# **Pentium® II Processor Specification Update**

Release Date: July 1999

Order Number: 243337-028

**Figure 1. UP Dual Ended Termination (DET)**

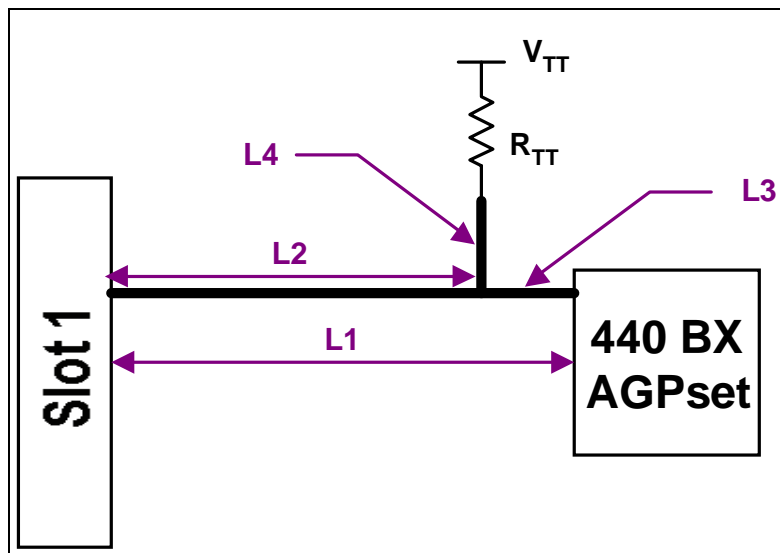
**IMPLICATION:** This violation of the bus exchange protocol when using a reduced arbitration latency may cause a system-level setup timing violation on the address, address parity, request command, or request parity signals on the system bus. This may result in a system hang or assertion of the AERR# signal, causing an attempted corrective action or shutdown of the system, as the system hardware and software dictate. The possibility of failure due to the contention caused by this erratum may be increased due to the processor's internal active pull-up of these signals on the clock after the signals are no longer being driven by the processor.

**WORKAROUND:** If the chipset and third party agents used with the Pentium II processor do not optimize their arbitration latency as described above, no action is required. For the 66 MHz Pentium II processor, no action is required. If agents that have implemented this optimization, by following the *100 MHz GTL+ Layout Guidelines for the Pentium® II Processor* and *Intel 440BX AGPset* for UP-SET (single-ended termination) and DP with both processors installed, no action is required. The following two cases are additional guidelines for UP-DET (dual-ended termination) and DP-DET with only one processor populated.

For UP-DET topologies (see Figure 1), the trace length L1 must be between 1.5" to 4.5" while using a 56Ω termination resistor.
